Pre-Plaster Report

Inspection Date: 30 Jul 2020

Property Address: Wollert Area

Report Type: New Home Construction

Non Compliant 2.01

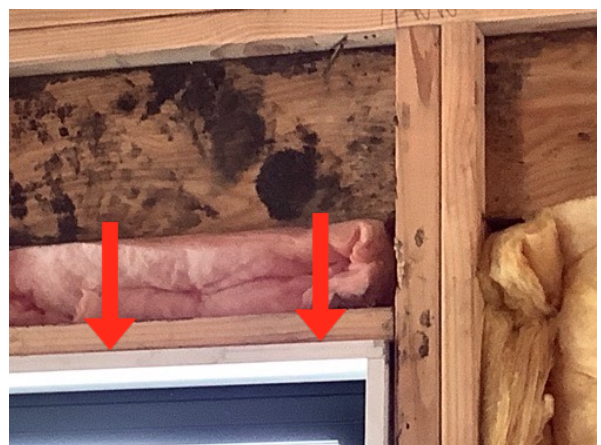
Finding: Top Of Window - Undersized Gap.
There are areas where the top of the windows are currently tight or well under 15mm to the underside of the timber lintels.

It is a requirement of Australian Standard, A.S 1684 Residential Timber-Framed Construction, clause 6.2.3 Openings, that 'A minimum clearance of 15mm shall be provided between the underside of the lintel or lintel trimmer and the top of the window frame'.

This opening and/or ALL openings that are under 15mm must all be modified in compliance with the above.

Non Compliant 2.02

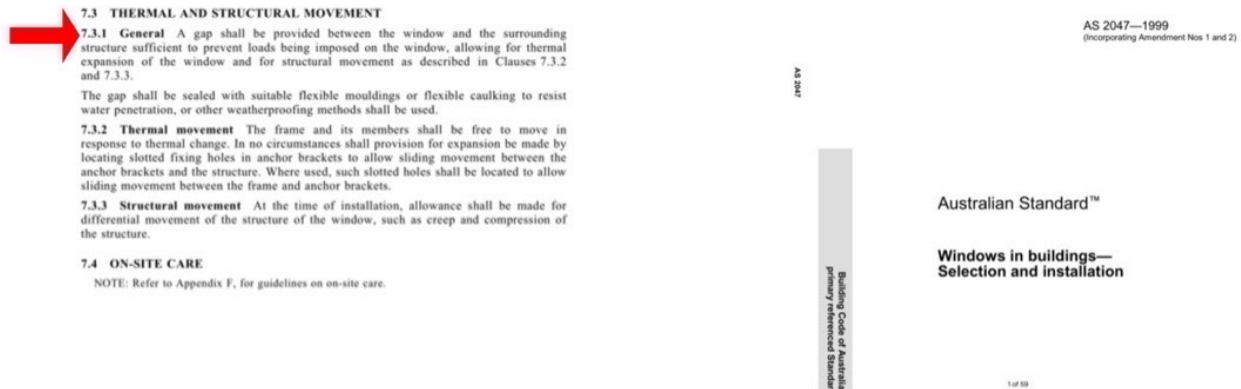
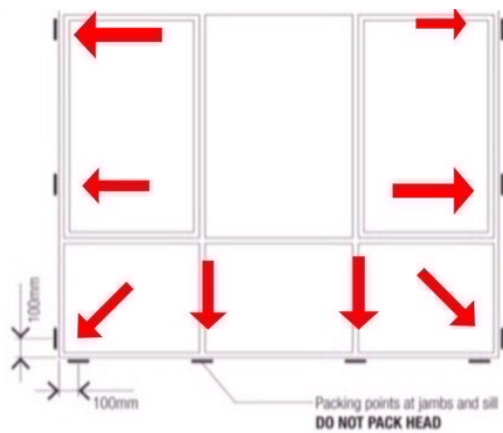
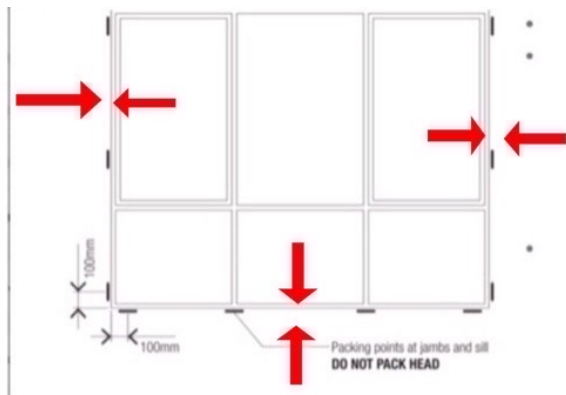
Finding: Window Installation - Gaps To Perimeter Of Windows Defective.
As per AS-2047-1999 and the defect clause is below.
All windows must have sufficient gap around them with a minimum of 15mm at the top of the window to the underside of the timber frame.
In this case the defect in discussion is the sides of the window and the bottom of the window DO NOT have a sufficient gap if any to allow for movement and compression of the frame.

ALL WINDOWS with no or insufficient gaps, also as per manufacturers standards is packing to the sides and bottom of the windows as well, must be reworked to allow a recommended of at least 15mm to 20mm of packing.

The packers must be as the manufacturers specifications.

Non Compliant 2.03

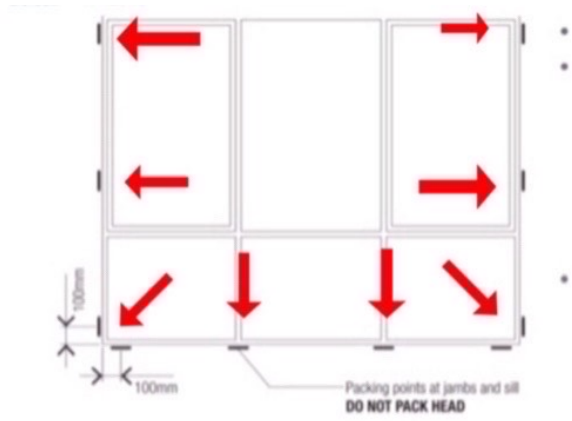
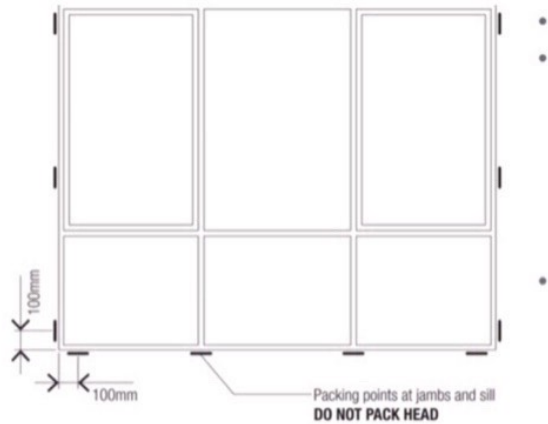
Finding: Windows - No Packing, As Per The Manufactures Specifications. (Or Packing Not Satisfactory)

Windows must be packed at the mullions as specified by the window manufacturers specifications.

In this case the defect in discussion is the sides of the window and the bottom of the window DO NOT have a sufficient gap if any to allow for movement and compression of the frame.

ALL WINDOWS with no or insufficient gaps, also as per manufacturers standards is packing to the sides and bottom of the windows as well, must be reworked to allow a recommended of at least 15mm to 20mm of packing.

The packers must be as the manufacturers specifications.

Non Compliant 2.04

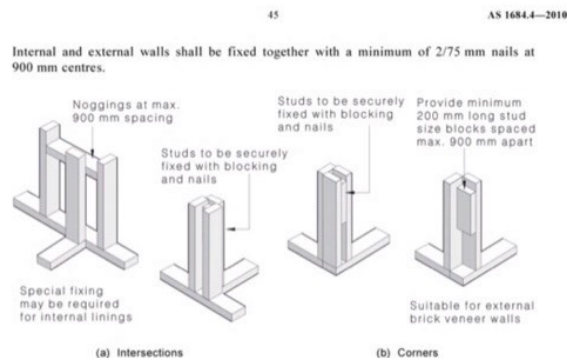
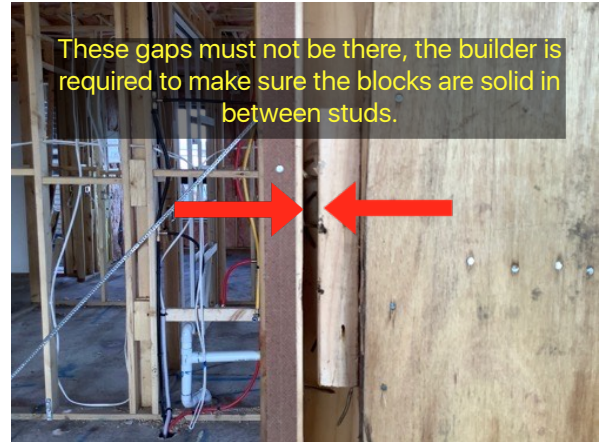
Finding: Blocking at intersecting walls - insufficient / undersized
 It was observed that the blocking of intersecting walls are insufficient in the nominated locations throughout the Structure.
 The AS1684.2 indicates that three blocks are required at intersecting walls (minimum length 200mm)
 At spacings not exceeding 900mm and each stud must be fixed to the block with 2/75mm nails.
 Where wall junctions are within a deemed wet area, blocks must be installed at a maximum of 600mm centres .

In particular the standard notes that all walls must be installed with noggings at a spacing not exceeding 1350mm and wall intersections don't negate this requirement.

It may be hard to see in the photo, however the three blocks that are minimum 200 mm long at all the intersections must be hard against the studs there are areas where there is a gap between the blocks and the studs of about 15 mm

Non Compliant 2.07

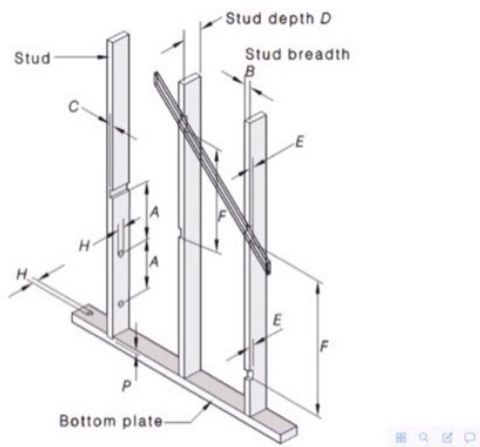
Finding: Services holes and penetrations - over sized
It was observed during inspection that the diameter/size of holes and penetrations exceeded the maximum size allowable as defined in AS1684.
AS1684 states that service penetrations to studs and plates shall not exceed 25mm and shall be placed central to the breadth or width of the member.
Consultation with the building surveyor or certifier is recommended to establish the correct course of action to overcome the existing installation of services to comply with AS1684.

Non Compliant 2.08

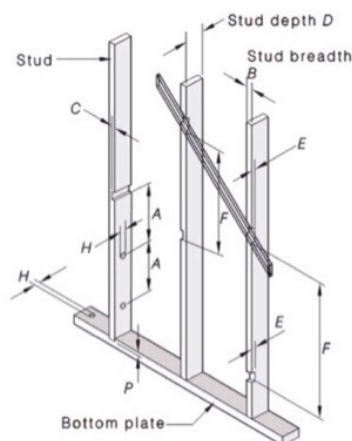
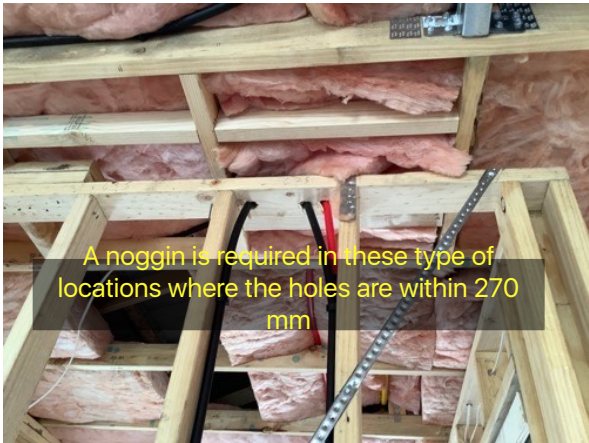
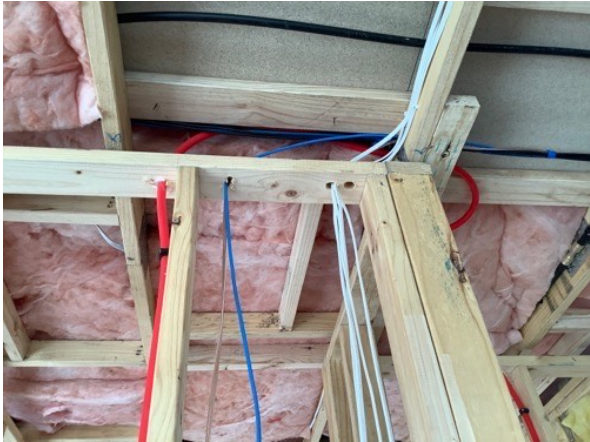
Finding: Holes and notching - insufficient distance.
It was observed during inspection that the minimum distance between holes for services (electrical and / or plumbing) and notching has not been maintained. The AS1684.2 2010, Page 60 and 61 requires a minimum distance between holes and notching in a 90mm stud and top plates is 270mm apart.
The standard (table 6.1) states that the distance between holes and other holes or holes to notches in studs can be no closer than $3 \times D$. This is calculated as $3 \times$ the depth of the material used. In this case $3 \times D$ is $3 \times 90\text{mm}$ or 270mm minimum distance apart.

A noggin is required in these type of locations where the holes are within 270 mm

Install a noggin on edge hard up against the top plate..Install two nails to each side of the studs and nail two nails into the top plate and into the noggin on edge.

The timber must be replaced and the rough in reinstalled at 270mm separation or the area beside the rough in cleated to add additional support to the stud.

Non Compliant 2.09

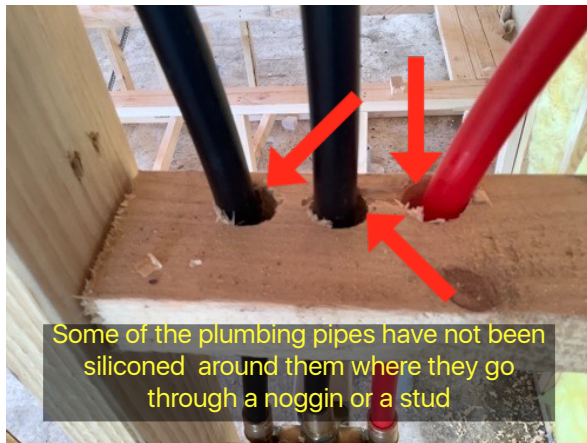
Finding: Plumbing lines passing through framing - Not Packed / Siliconed.
It was identified that there are instances where the water plumbing supply lines pass through studs and top plates and between noggins that have not been packed with silicon or similar material at each hole to stop water hammer or vibration.

AS 3500.1, clause 5.5.2.1 calls for the space to be filled.

All pipes that run through walls must be fully secured in place with all movement restricted by all possible means.

Non Compliant 2.10

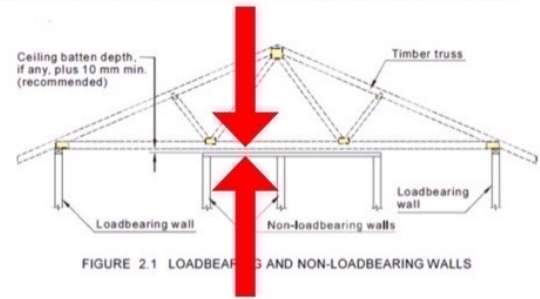
Finding: Walls / Bulkhead built hard up to the trusses

The bulkhead along the Kitchen wall has been blocked up off the top plates to align the ceiling, a practice that will now stop the trusses from being able to deflect as they were designed too; as well as now making the internal non load-bearing walls load-bearing.

The relevant Australian Standards A.S 1684 Residential Timber-Framed Construction, states in section 6.2.5.2 Internal Walls – Trussed Roofs, that ‘Non Load-bearing walls shall be kept a minimum of 10mm below the underside of the bottom chord, or ceiling battens when used’. While A.S. 4440 Installation of Nail-plated Timber Roof Trusses, state in section 2.2.2 Non Load-bearing Walls, that ‘Non load-bearing walls, as designated, shall not carry any truss loading and shall not be packed to touch the underside of trusses (see Figure 2.1)’.

A.S. 4440 Installation of Nail-plated Timber Roof Trusses, also state in Appendix B2 Camber, that ‘Trusses are built with camber to allow for the initial deflection at the take up of load and some creep (i.e. long-term deflection) as the timber settles. Thus, packing to the underside of a truss over a non load-bearing wall may stop these deflections and in turn support the truss in an incorrect position’.

This blocking must be removed and the ceiling lines straightened using one of the other available methods.

Non Compliant 2.11

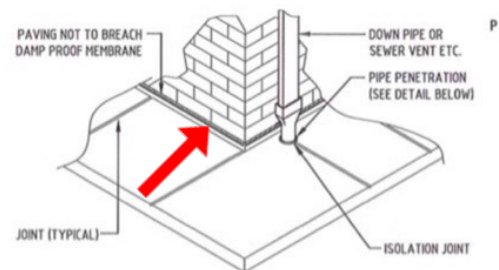
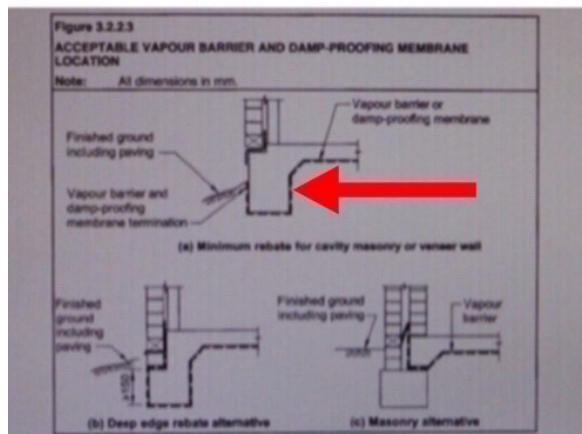
Finding: Vapour barrier - Defective (AS2870- 2011)
 I HIGHLY RECOMMEND that the builders dig the entire perimeter carefully, without damaging the plastic and extends the vapour barrier plastic 600mm as it was in the slab inspection statement.
 The over lap must be a minimum of 200mm and the correct tape must be used and sealed both sides 100%.

The functionality of the vapour barrier to the entire perimeter of the building including, between the the buildings each side of the house is being compromised due to poor workmanship during the installation/construction process.

It is a requirement of AS 2870-2011 5.3.3.4 that vapour barriers are turned up and terminated at ground level above pavement adjacent footing. The vapour barrier is defective if building materials and fill has been left on top of the membrane, as this prevents it from being pulled up against the slab when installing perimeter paving as it is intended to be.

This must be remedied immediately to prevent slab edge dampness.

Non Compliant 2.12

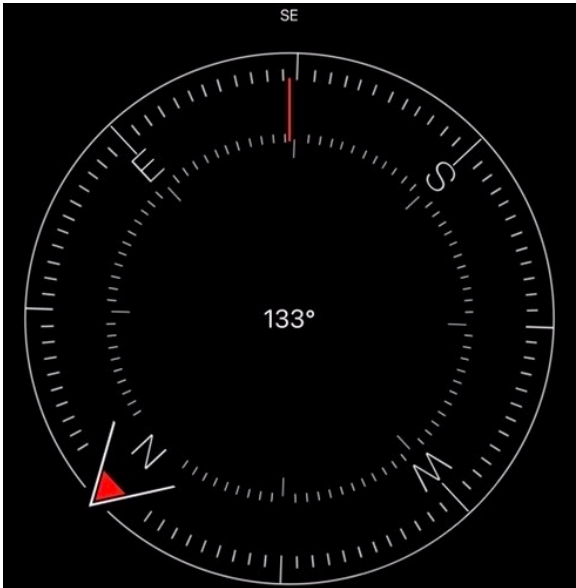
Finding: Shower stud width NOT Acceptable.
The shower recess requires additional studs to be added to comply with the requirements of the BCA and the framing standard.
Although some building elements may seem irrelevant or unnecessary, all building elements play a key role in the operation and function of the overall structure and its performance. This wall or common studs need to be placed at centres no greater than 30cm and noggins must be spaced between at the same line as the rest of the dwelling no greater than 180mm off set.
Replacement of any missing building element should be conducted as soon as possible to ensure that no damage or functional issues occur to associated building materials.
